From: LeRoy, Bruce J - DNR (BJ)
Sent: Monday, July 1, 2019 11:51 AM
To: 'Jeff Tracy'
Cc: 'Marita D. Stollenwerk'; Wedekind, James; 'Lori Rich'
Subject: RE: Ripon FF/NN Landfill - Sentinel Well Monitoring

Subject: Sentinel Well Proposal
Ripon HWY FF/NN Landfill License #467
BRRTS No. 02-20-000915

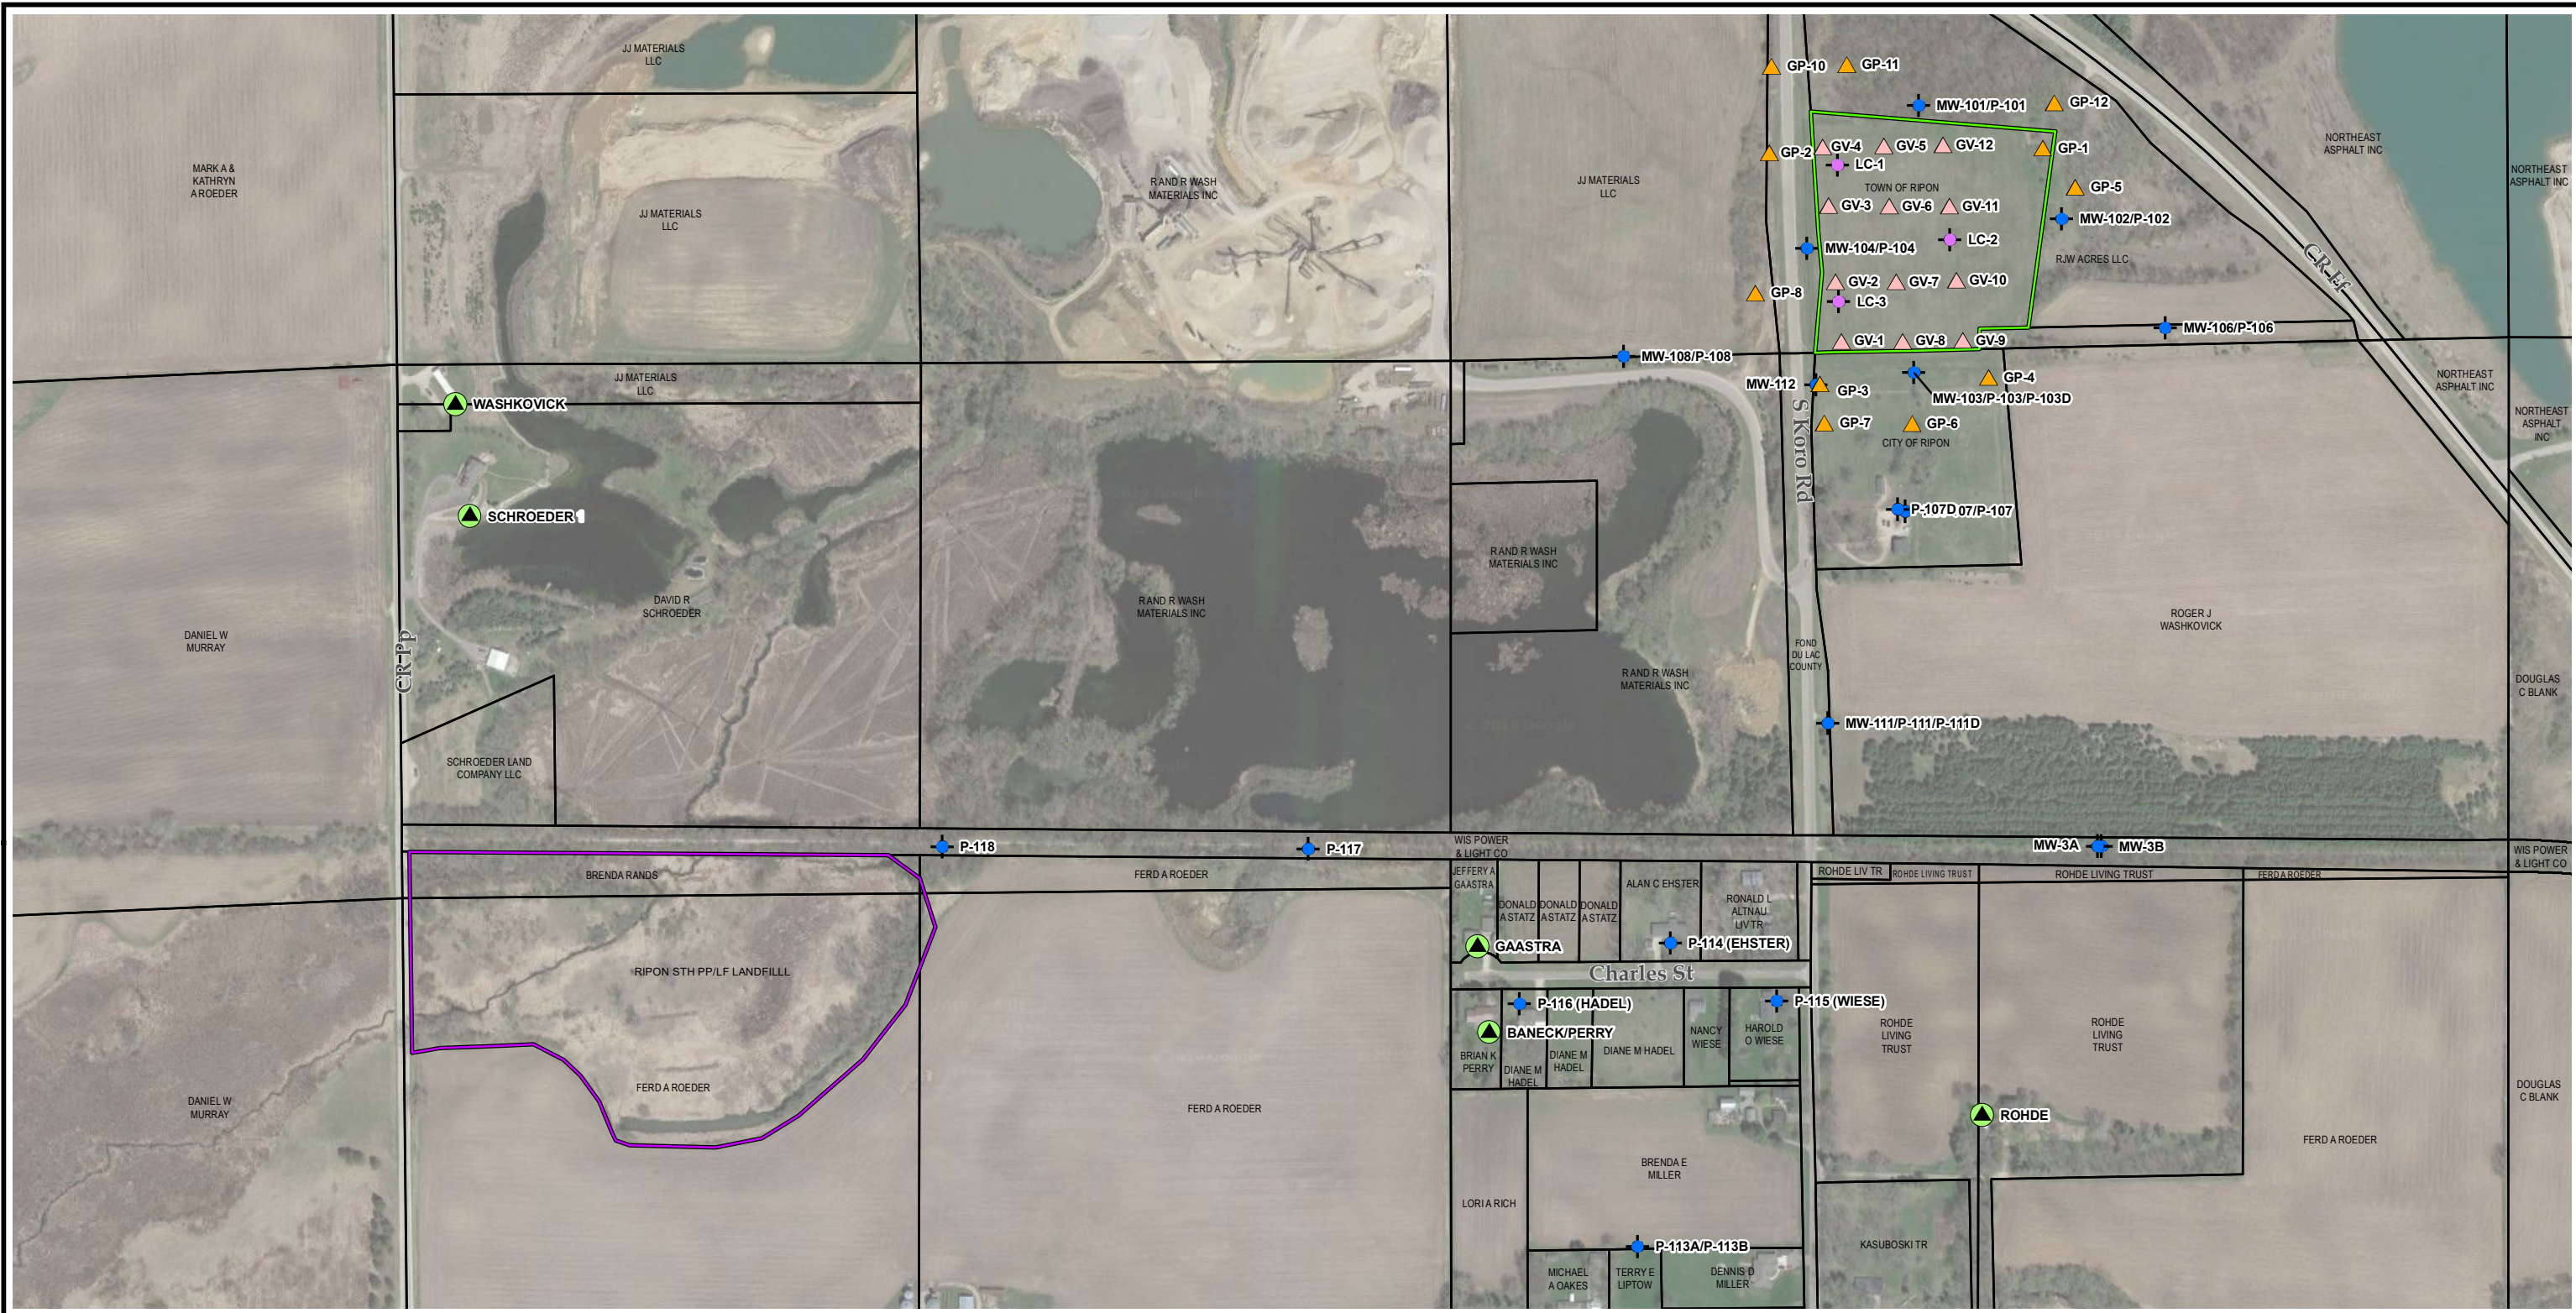
In a cursory review, I'm not ready to give up on the idea of a further sentinel well. That said, I'm not sure that it's warranted right now, not having established a trend of detects at P118. It looks like two detects in the last eight rounds, with the latest being ND and likely another sample result at the lab or in your hands.

The plume is either expanding or not regardless of the method or the limited data we have. I'd say, regarding the "expanding plume" that it was our knowledge of the plume's physical location that expanded. We've not yet shown that it's physically expanding beyond P-118, though it's certainly reached that location. An up-to-date plume map may be a good idea in the next quarterly report.

As I look at the detects and the flow map, my thoughts are first that we seem to have bounded the SE portion of the plume, at P113/P116. Gastra had a couple recent hits that were concerning. Flow is W/SW in Layer 3 according to the previous maps. At the moment I'd be most concerned with the Roeder property, SW of P117. We know P118 has had detects and flow is in that direction, so the Roeder location is probably a private well that should be sampled if it hasn't already been. It appears there is a farm on the SW corner of that property.

I think your time may be better spent looking at the groundwater flow in that overall area, improving the flow map if possible, incorporating any data you can from the adjacent landfill (guessing there is data in BRRTS). If there is no data in BRRTS, maybe I can get permission to use the data from GEMS. And of course a recent plume map.
